Spinifex Ridge Molybdenum Project

November 2007

RESPONSE TO SUBMISSIONS

Figure 1
Project Layout

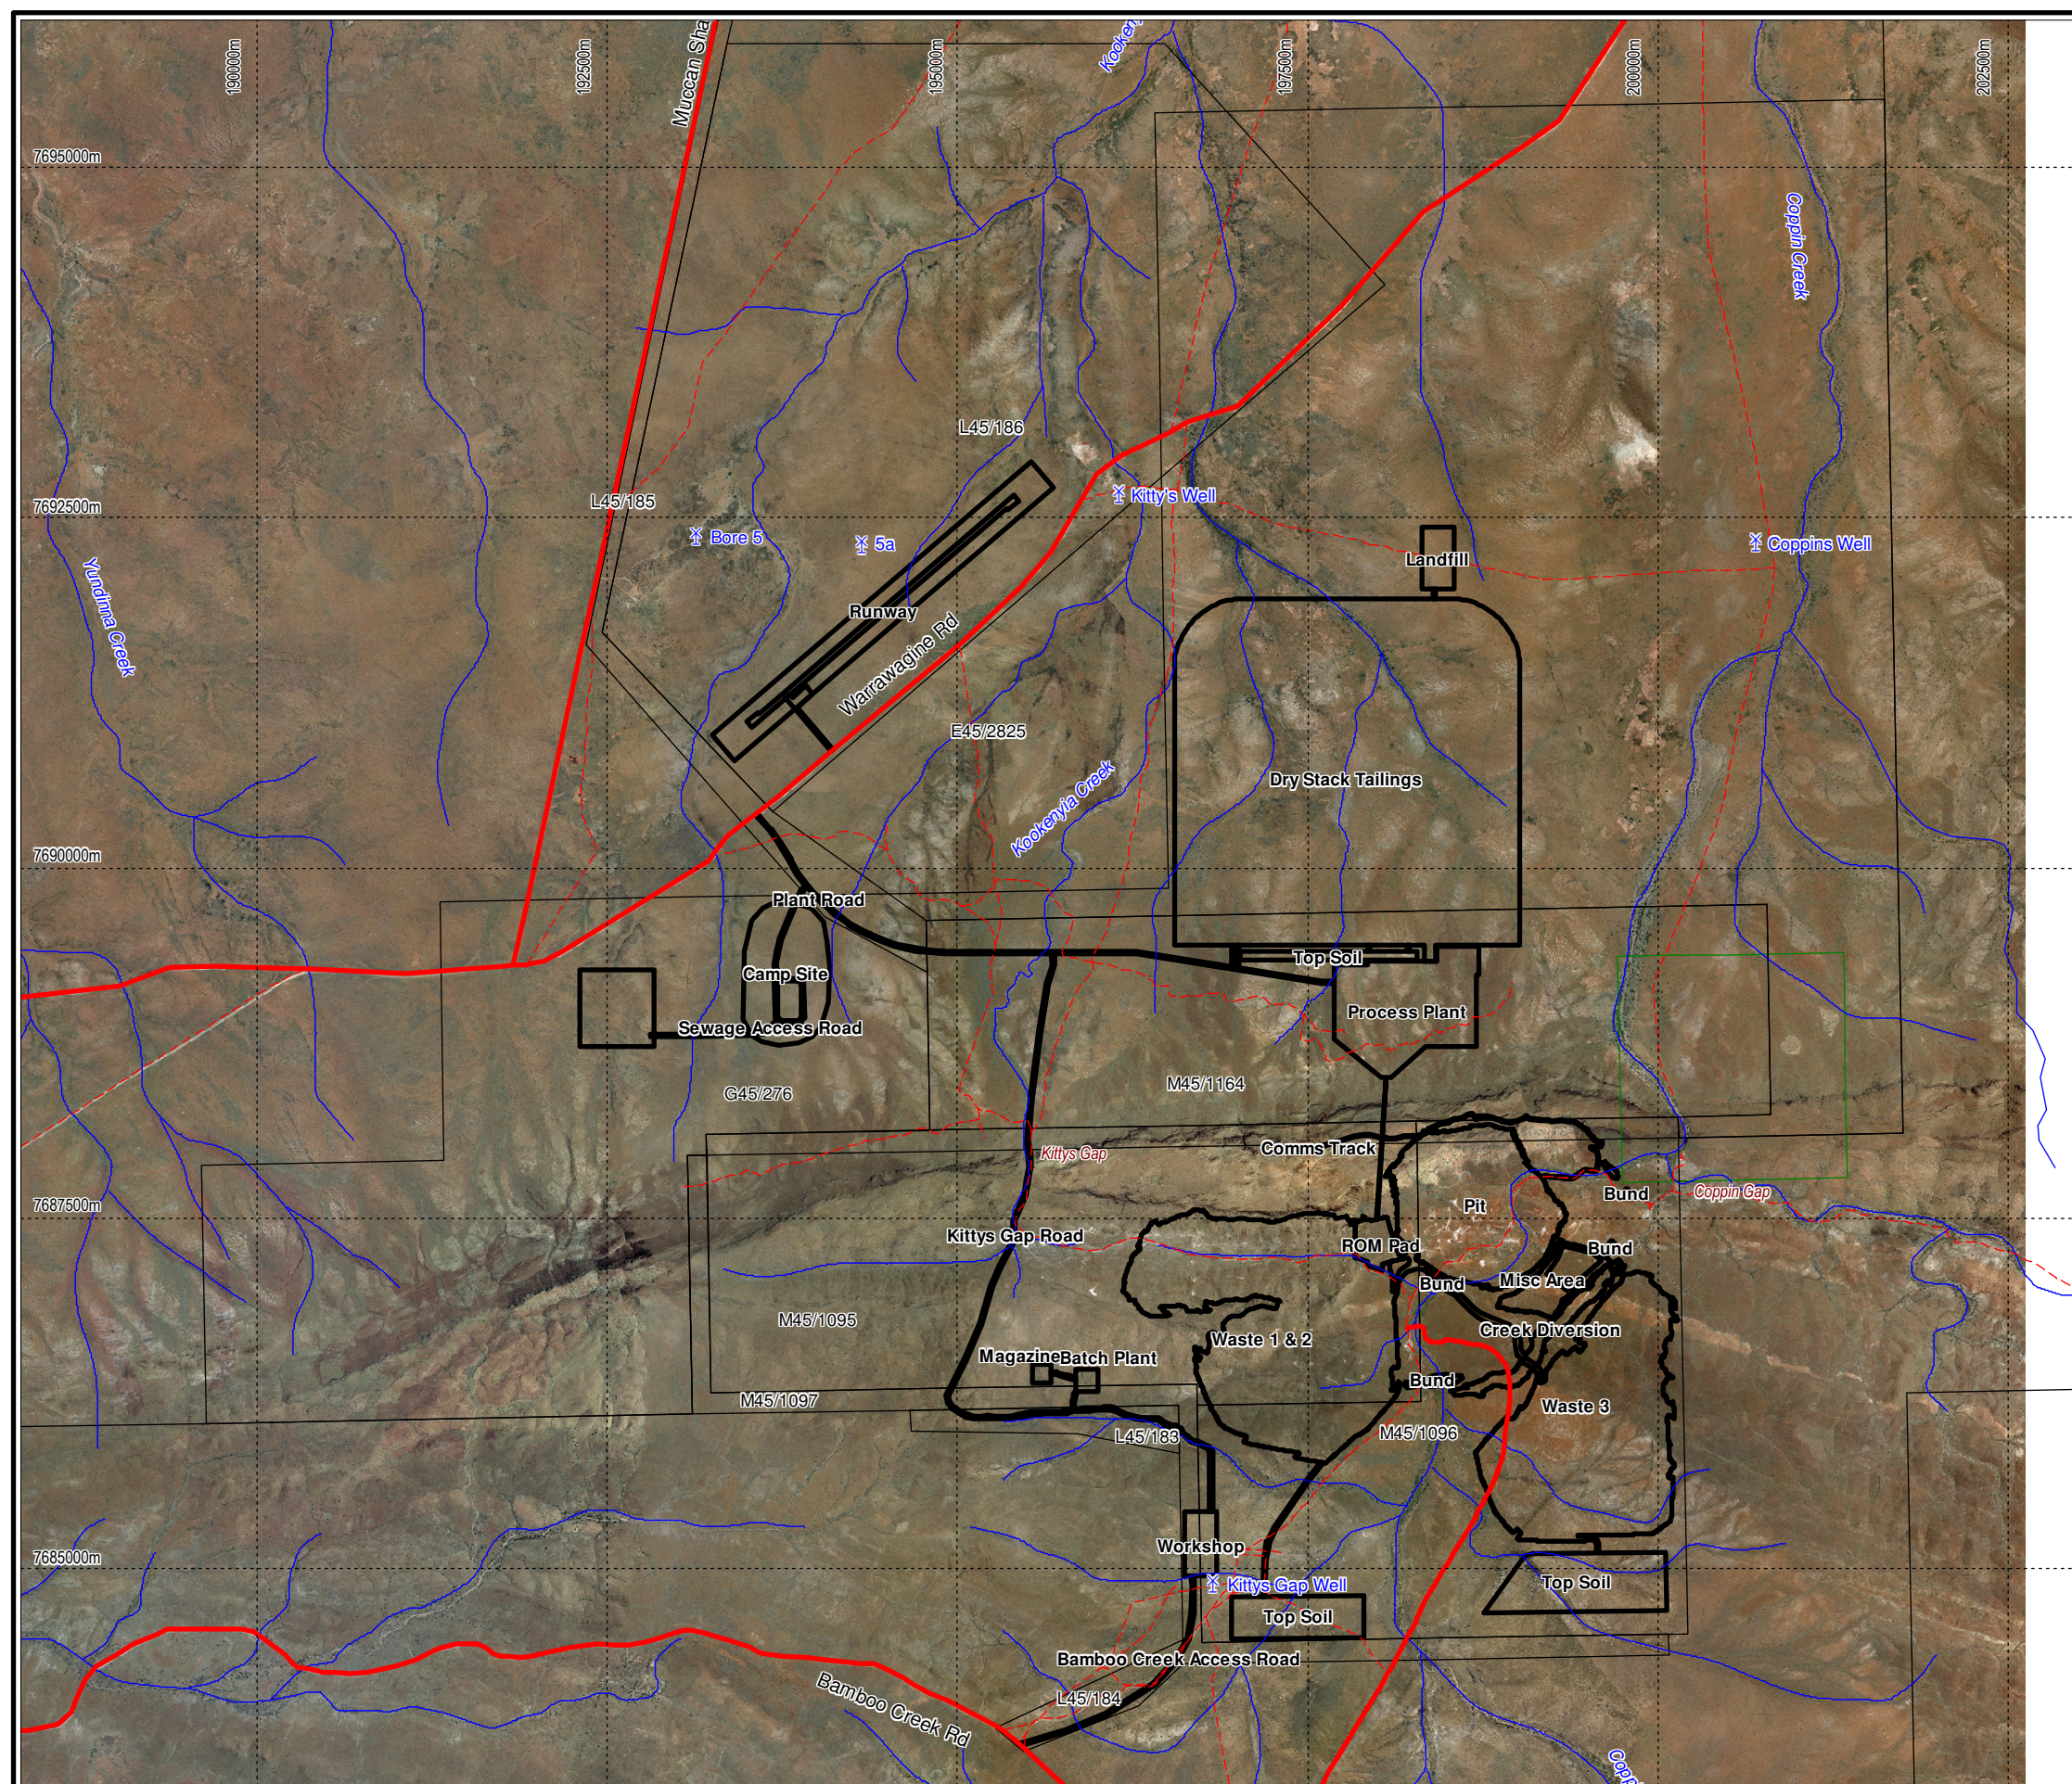
The waste dump footprint has been modified slightly based on environmental considerations (Figure 2.1). The northern extent of Waste Dump 3 has been trimmed to ensure that the dump does not encroach on the minor creek line that flows into Coppin Creek just south of Coppin Gap during episodic rainfall events.

The airstrip has been moved closer to the camp and processing plant (Figure 2.1). This location is impacted less by drainage lines and allows for a more consolidated overall project layout. The requirement for a temporary strip, as presented in the PER, has been reviewed and will no longer be constructed.

As outlined in the PER, road alignment is likely to change based on environmental considerations through the detailed design phase. Some of these changes have already been identified and are presented in Figure 2.1. As an example, the road from Kitty's Gap will no longer cross Kookenyia Creek, but will go straight north to the Processing Plant access road. As well as eliminating the requirement for a substantial creek crossing, the overall road distance will be shortened, resulting in less disturbance.

Figure 2
1 in 100 Year Flood Level

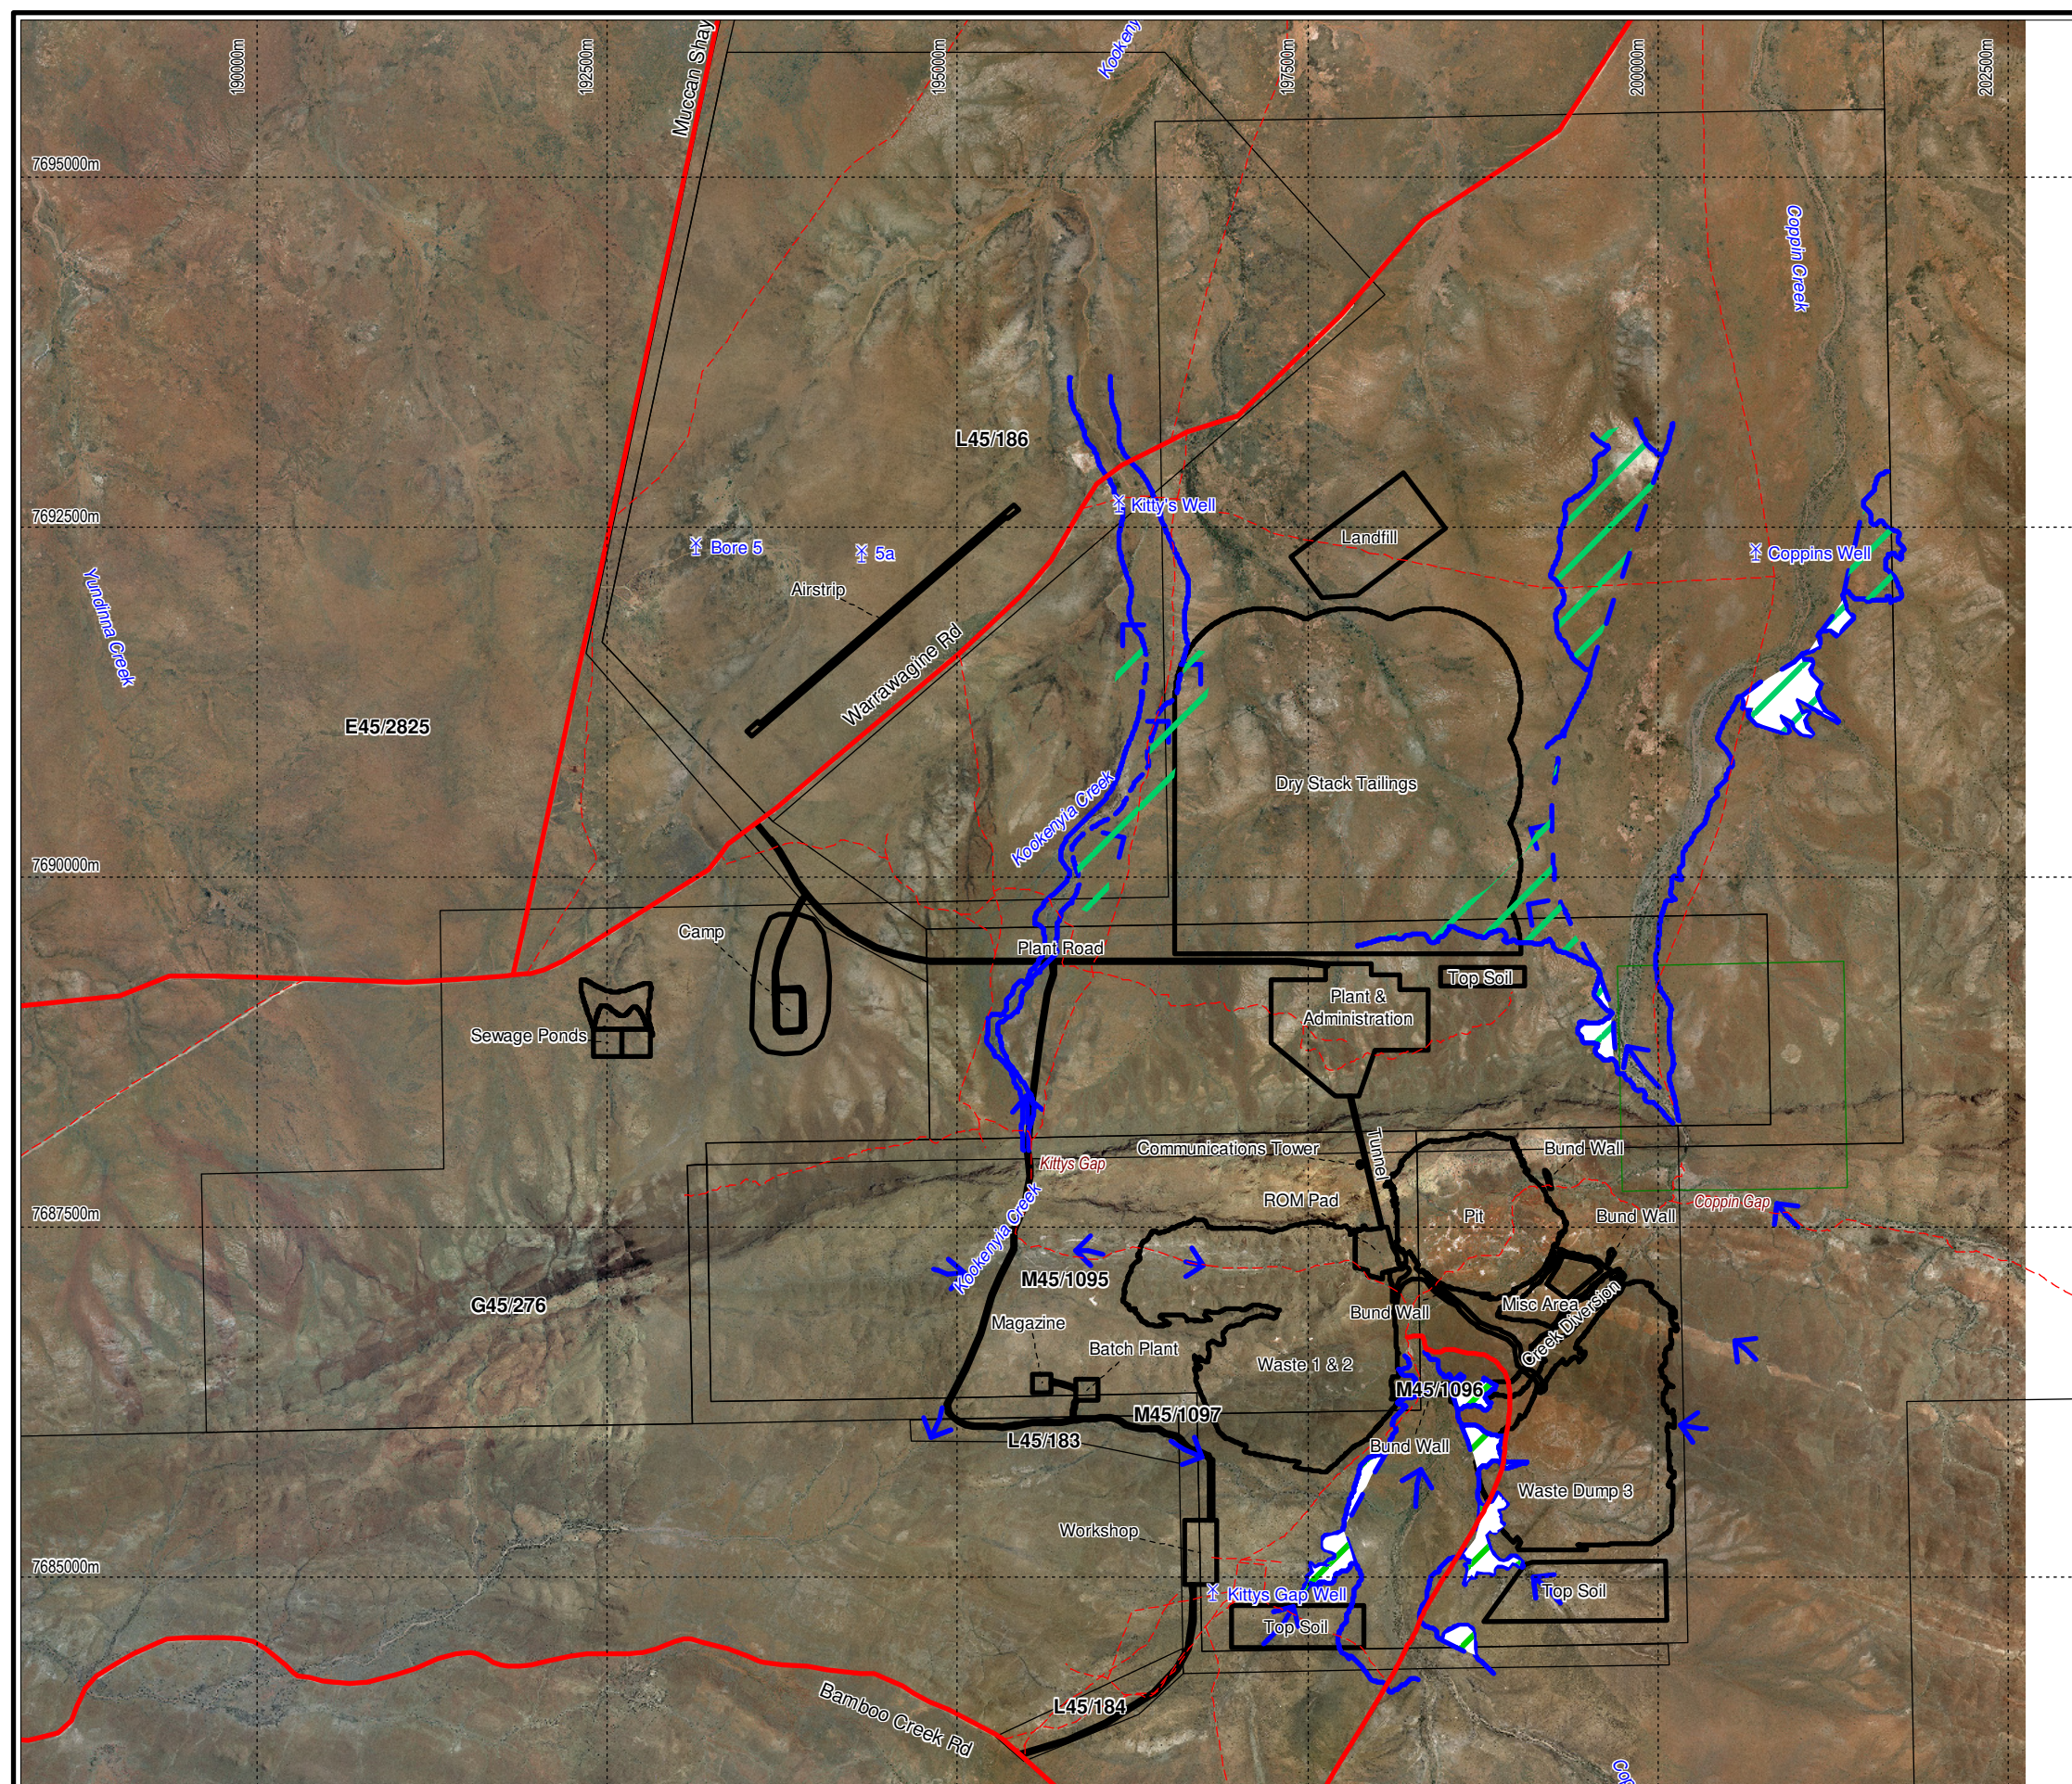
DOIR	Surface water	All permanent infrastructure (e.g. TSF, WRDs) should be outside the area flooded by 1in 100, 72 hr rainfall event, and armoured to withstand a potential maximum flood event (based on a geotechnical assessment of design), to ensure stability at closure. If the creek diversion will remain post-closure, the extent of flooding from this drainage line also needs to be considered. A figure showing the extent of the areas flooded by a 1in 100, 72 hr rainfall event, in relation to project infrastructure, should be provided.	A new figure has been drawn showing the floodplains and the proposed locations for mining infrastructure and is attached (see Figure 2). Permanent infrastructure such as the TSF, waste rock dumps, plant site, camp site and the open pit are located outside the main 100 year ARI floodways of Coppin and Kookenyia Creeks. Water in the flood fringe areas may pond against some structures, but with no erosive force. At these locations, bunding shall be used to divert flows downstream and armouring or other erosion protection will be provided as required. The diversion channel has been designed to cope with a 100 year ARI flood along Coppin Creek, with engineered bunding installed to ensure water is diverted down the channel and through Coppin Gap.

Submitter	Issue	Submission Issue	Response
DOIR	Surface water	<p>Specific concerns are raised regarding:</p> <ol style="list-style-type: none"> 1. W margin of WRD3 may be impacted by flooding of the creek diversion channel; 2. E margin of WRD2 may be impacted by flooding of Coppin Creek; 3. W margin of TSF impacted by flooding of Kookenyia Creek. If location of the TSF in this area cannot be avoided, geotechnically designed armouring to withstand a potential maximum flood will be required; 4. Topsoil stockpiles should be located outside the area flooded by 1 in 100, 72 hr rainfall event, or appropriate bunding installed. Topsoil stockpiles 2 and 4 may be impacted by flooding of nearby creeks; 5. The NE corner of WRD3 extends marginally over the creek to the N of the dump, the dump footprint should be expanded elsewhere to avoid this impact. 	<ol style="list-style-type: none"> 1. The western margin of WRD3 was incorrectly shown to intrude into the diversion channel. WRD3 is set back from the diversion channel and will not be impacted by this flow (Fig xx) 2. The eastern side of WRD2 above the diversion bund has been located outside of the floodplain. 3. The revised TSF has been positioned outside of the Kookenyia Creek floodplain 4. Topsoil stockpiles have been located outside 100 year ARI floodways. The potential for erosion will be considered for all topsoil stockpiles and appropriate bunding established. 5. The north east corner of the WRD3 footprint has been modified to ensure it does not intersect the creek flowing to the north of the dump.

DOW	Surface water	Uncertainties in water management planning at the mine site due to the complex nature of local hydrology and hydrogeology,	Surface and groundwater management plans have been prepared and are presented in the PER. The proposed management outlined in these plans allows for review of monitoring data to modify management as knowledge increases.
DOIR	Surface water	The extent of flooding caused by a 1 in 100 year, 72 hour rainfall event should be shown in a figure, for all creeks, and the creek diversion, in the project area. This figure should also show direction of creek flows, for example it is unclear whether the creek W of WRD1 & 2 will flow towards Kitty's Gap, or into the WRD.	The 1 in 100 year floodplains in Kookenyia Creek (downstream of Kitty's Gap) and Coppin Creek (upstream and downstream of Coppin Gap) are shown in the PER Appendix H, Surface Water Assessment. WRD1 is designed to be built to the western extent of the valley draining into Coppin Creek. WRD1 has been kept out of the catchment for Kitty's Gap. A single, revised, figure showing floodplains, surface water flows and the proposed locations for mining infrastructure is attached.
